ADA site access relocation

FORM P3: ADMINISTRATIVE DECISIONS AND MINOR AMENDMENTS**_ ARCHAEOLOGICAL CERTIFICATE**

**RE: Minor Amendment- 2110 Carlisle Boulevard NE
Planning case file # PR-2019-002677**

PROJECT TITLE: CARLISLE CROSSING
2100 CARLISLE BLVD NE
ALBUQUERQUE, NEW MEXICO

ADMINISTRATIVE AMENDMENT

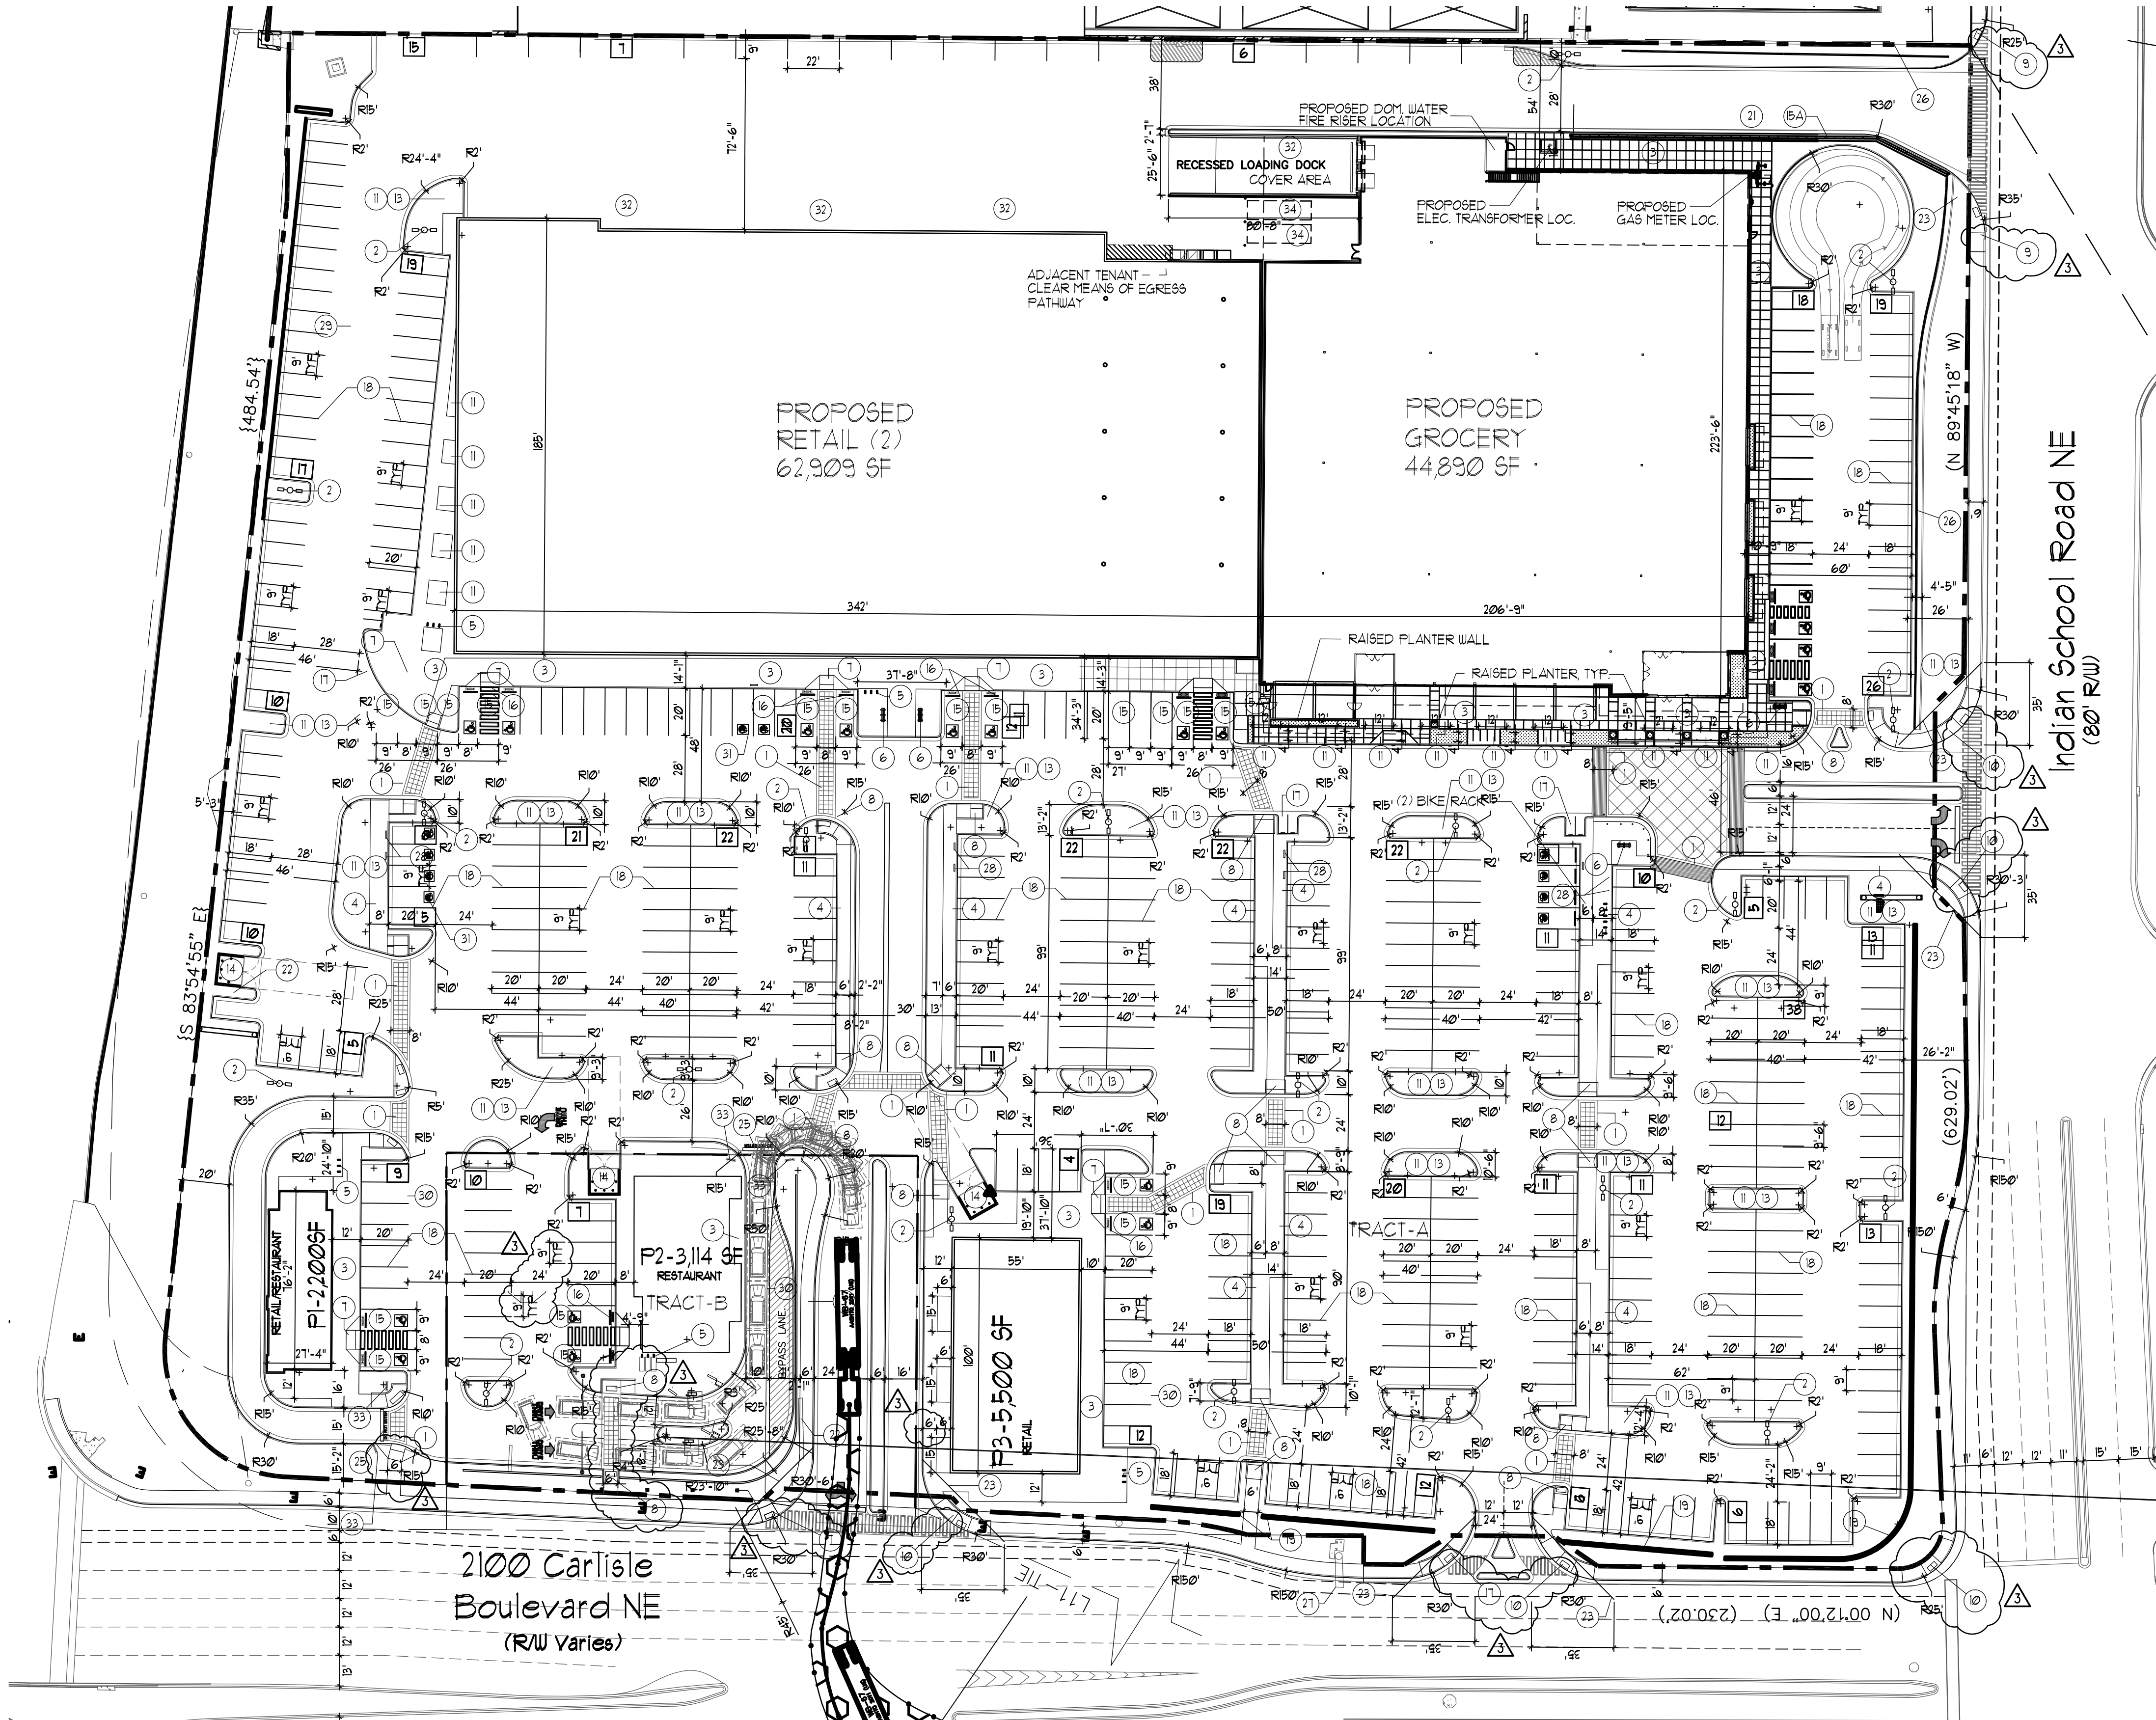
Removal of existing building pad in SE portion of site; Modification of SE corner of

parking lot into a traffic circle; Removal of (3) of (4) existing docking areas;

Reconfigure existing restaurant access; Modifications to existing landscape plan to
accommodate amendments.
